Maule Aircraft Corporation

Service Letter #14
Subject: Modification of Rudder Trim Tab Hinges
Models & Serial Numbers Affected:

(AD#68-07-08)

VIEW OF REVISED INSTALLATION

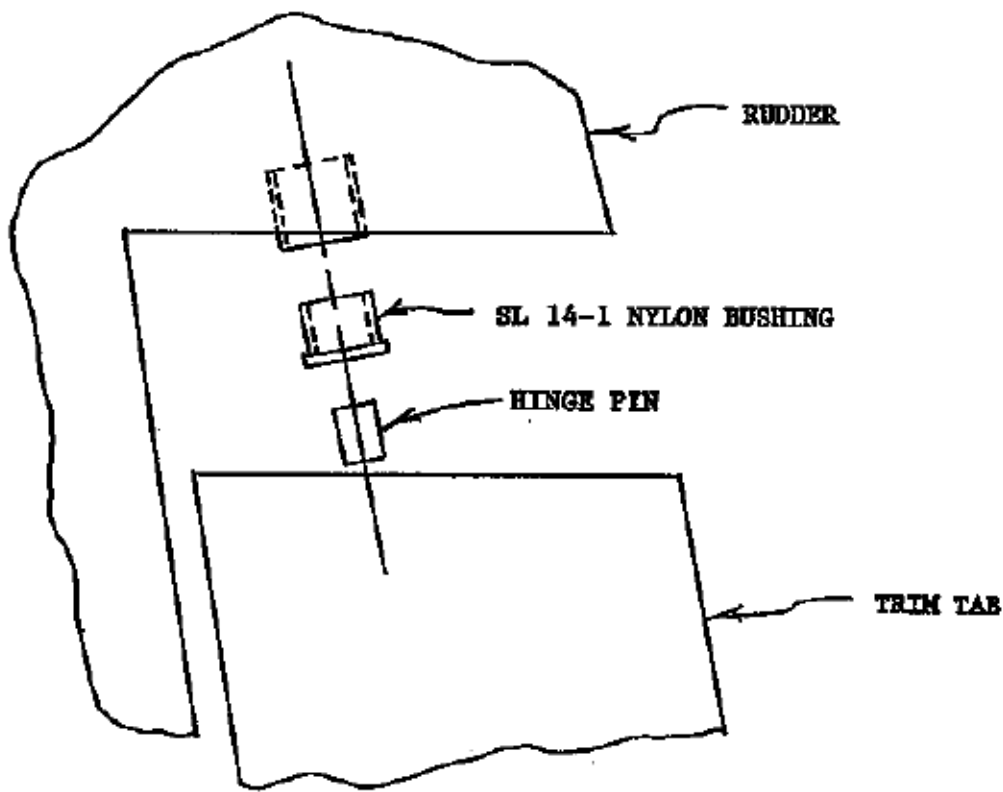
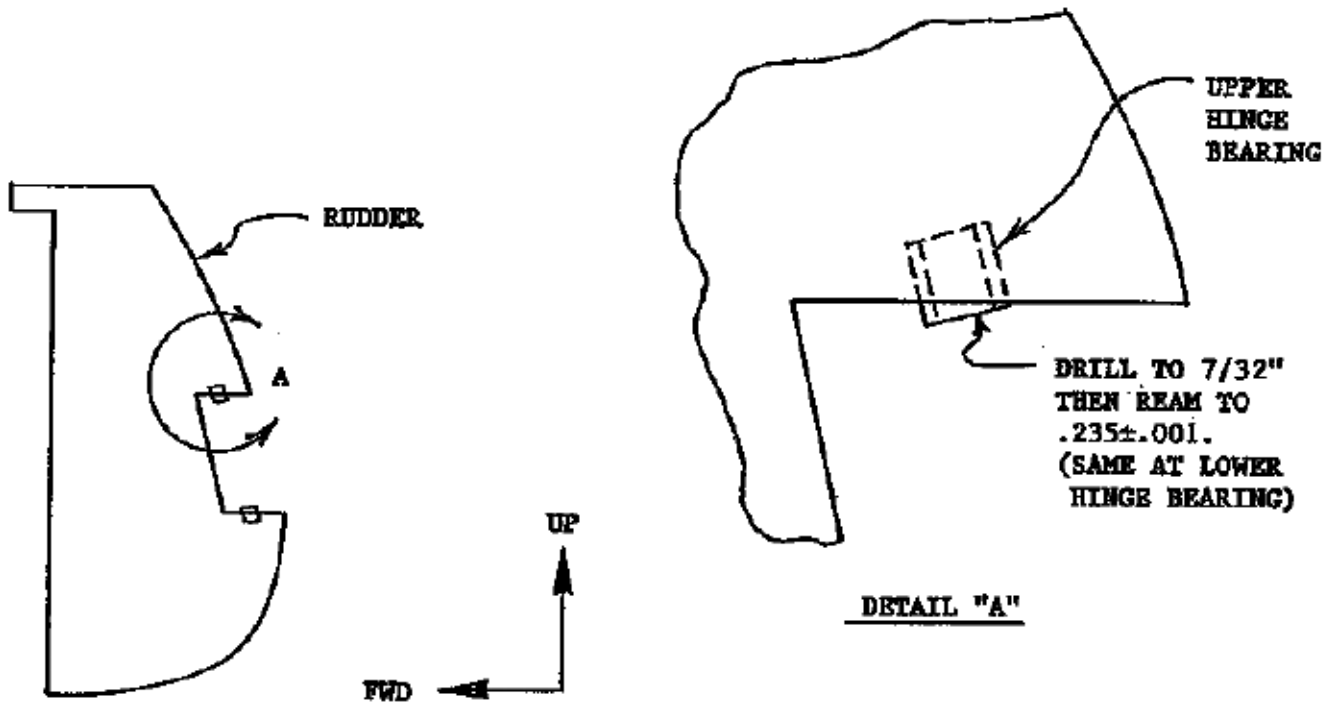
There have been instances of the rudder trim tab hinges corroding and seizing due to lack of adequate lubrication. To preclude such a condition, modify the hinge assemblies as detailed below and as shown on the attached sketch:

1. Remove the rudder trim tab from the airplane by removing screws from:
 - (a) The upper hinge pin block for aircraft with metal skin trim tabs, or
 - (b) Lower hinge pin block for aircraft with fabric tab.
2. Drill both upper and lower tab hinge bearings (on rudder frame) to $7/32"$. Then ream out to $.235" \pm .001$, carefully maintaining the hinge line alignment. See Detail A.
3. Install the nylon bearings (Part Number SL 14-1) by pressing them into the reamed bearings.
4. Clean and lubricate the trim tab hinge pins.
5. Install the trim tab to the rudder in reverse order of Instruction #1. Adjust trim tab for full travel of 52° left and 52° right $\pm 4^\circ$.
6. Complete the enclosed Service Letter Compliance Card and mail it to the Maule Aircraft Corporation:
